TRANSMITTAL COVER SHEET

DATE: 21 June, 2024
TO: ALL PLAN HOLDERS OF RECORD
FROM: HUNTER SWATEK, AIA, PROJECT MANAGER
PROJECT: RAINBOW CITY RECREATION CENTER
GMC PROJECT NO. ABHM230021
RE: ADDENDUM NO. 3 AND
ACKNOWLEDGEMENT OF RECEIPT OF ADDENDUM NO. 3

ADDENDUM NUMBER 03

**PROJECT: RAINBOW CITY RECREATION CENTER
GM&C PROJECT NO. ABHM230021**

REFLECTED CEILING PLAN - LEVEL 1

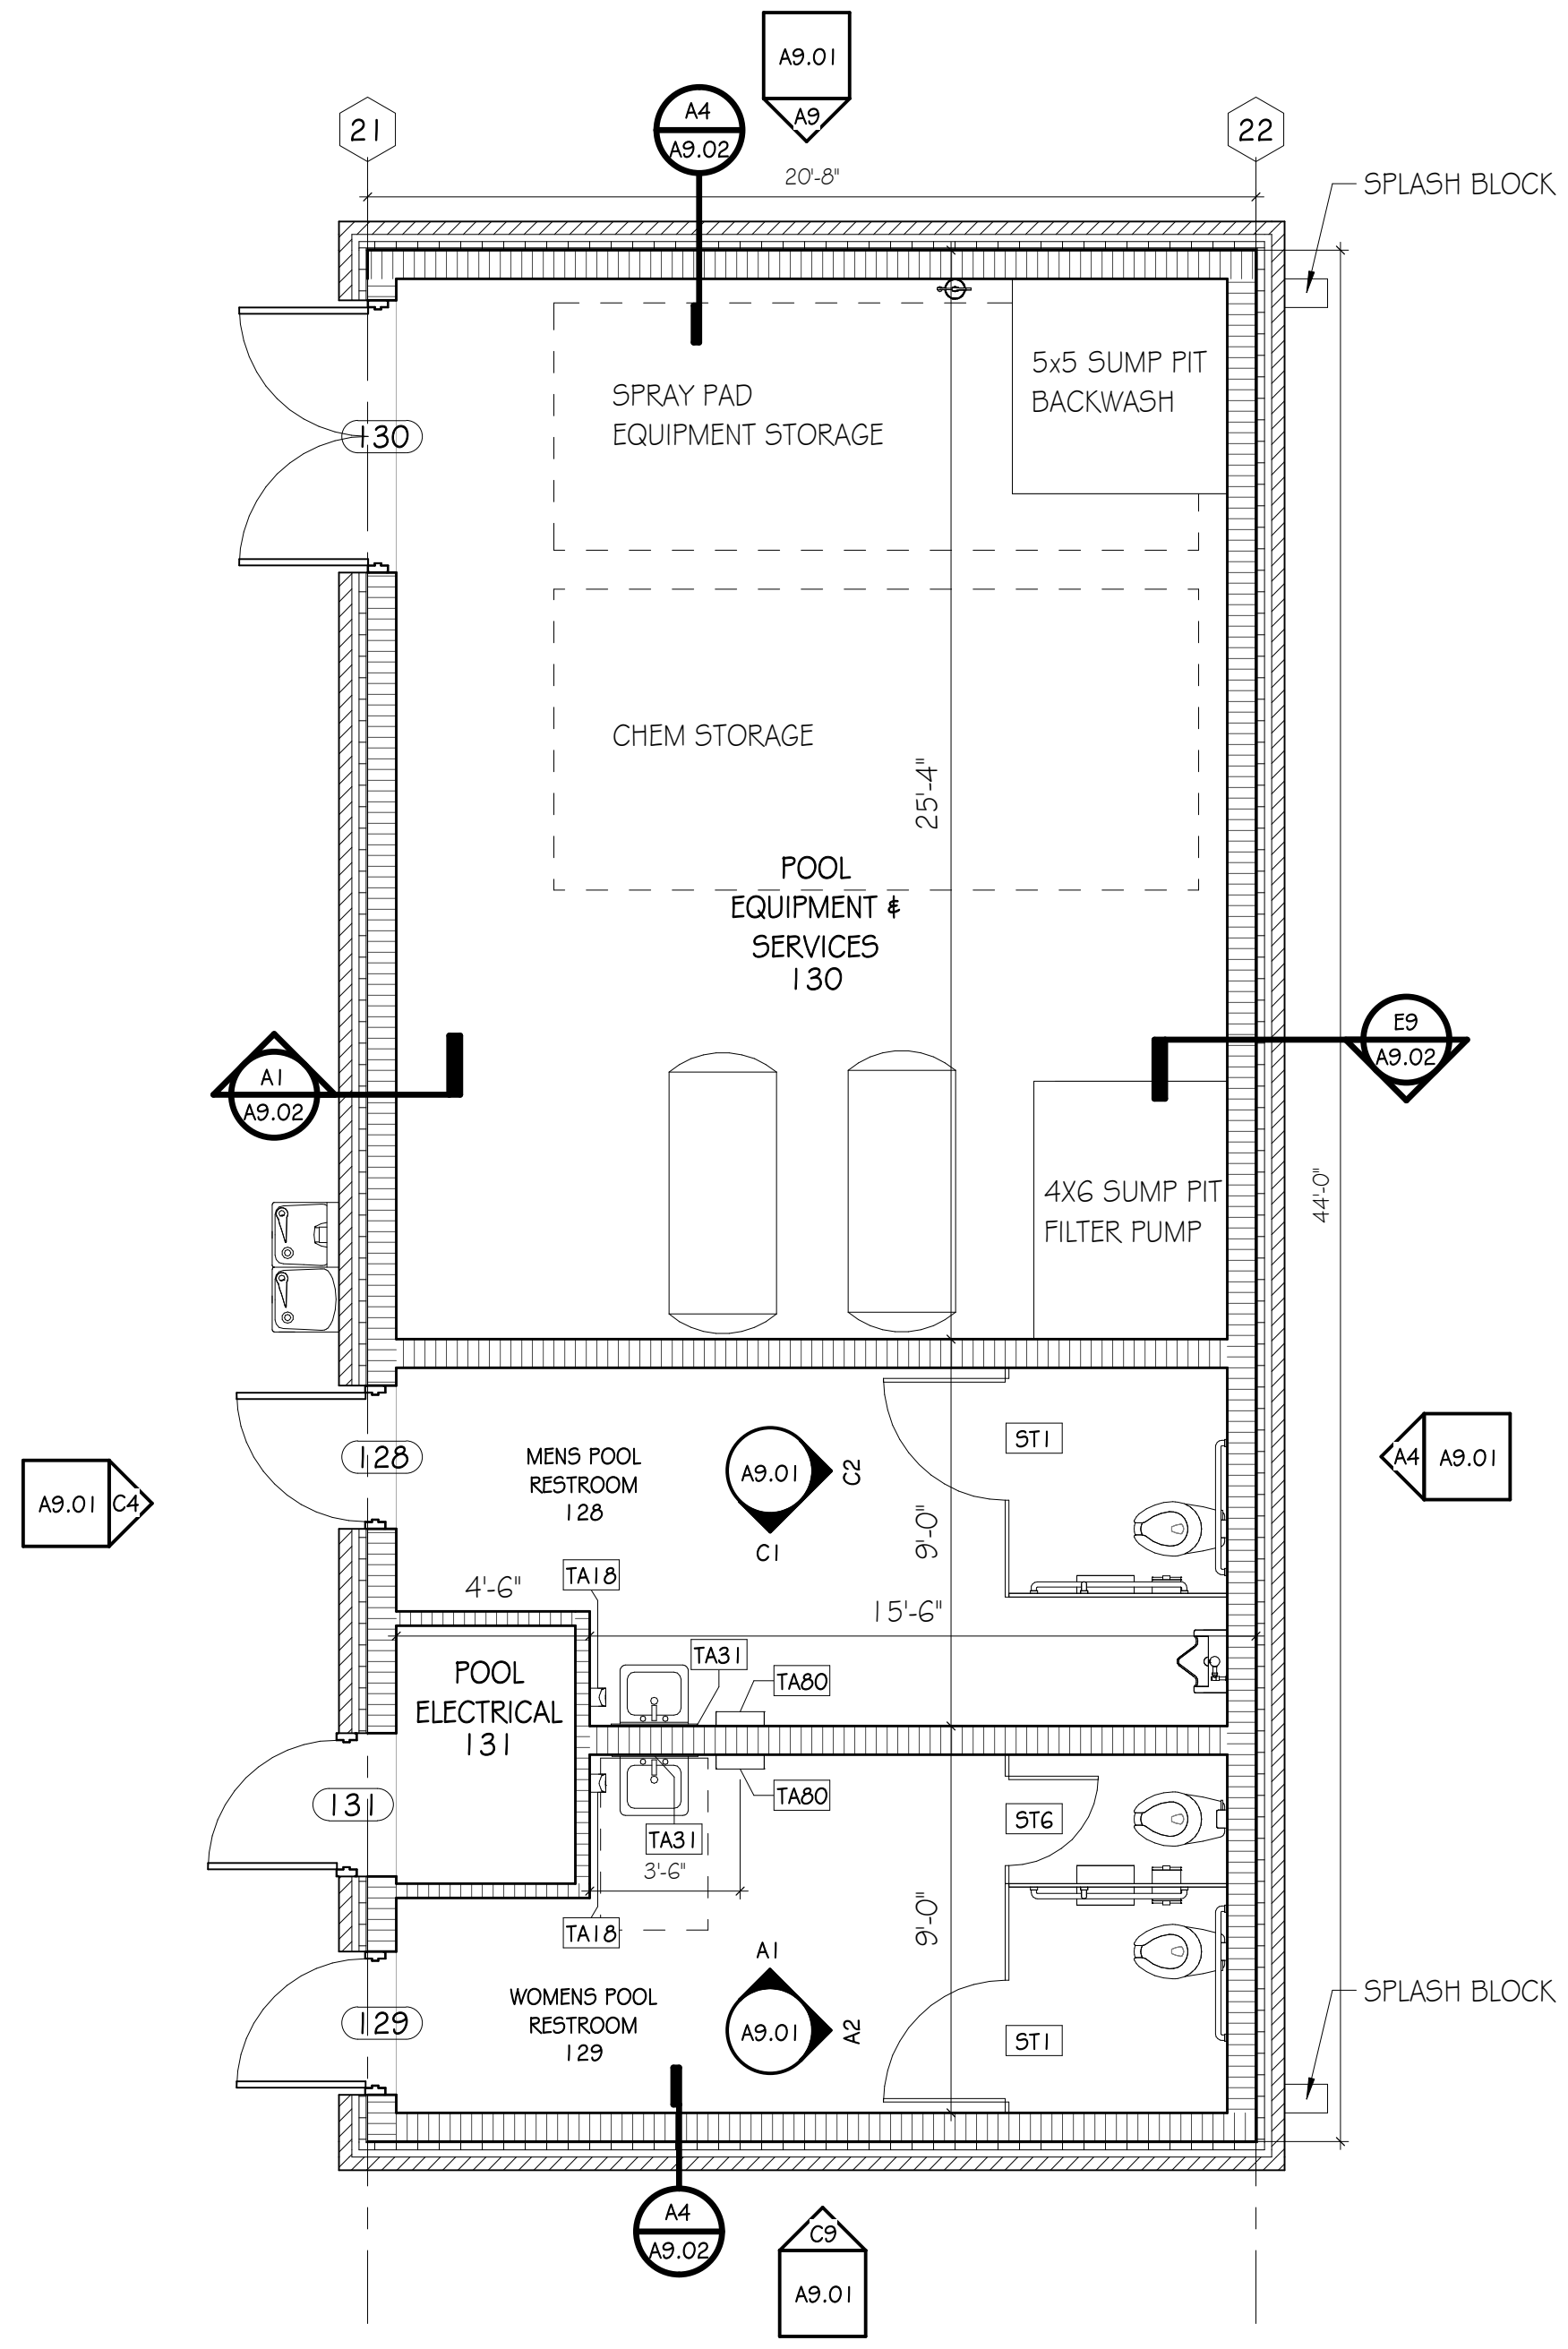
- A. **A2.01** – Reflected Ceiling Plan – Level 1
 - a. REVISED Concessions and Catering ceiling type
- B. **A9.01** - Pool Equipment Building
 - a. REVISED sheet drawings
 - b. ADJUSTED structural overhang depth in RCP
- C. **A9.02** - Pool Equipment Building Sections & Details
 - a. CREATED new sheet with roof details
- D. **A9.03** - Dumpster Enclosure
 - a. CREATED new sheet with plan, sections and details
- E. **A9.04** – Amphitheatre
 - a. REVISED sheet
- F. **C-101** – Site Layout Plan
 - a. ADDED Pool Collector Tank location
 - b. ADDED Wheel stops at parking adjacent to pool
 - c. REVISED Dumpster pad enclosure
- G. **C-102** – Alternate Site Layout Plan
 - a. REVISED Notes
 - b. REVISED Playground
- H. **C-201** – Grading Plan
 - a. REVISED grading around pool house and playground
- I. **C-202** – Alternate Grading Plan
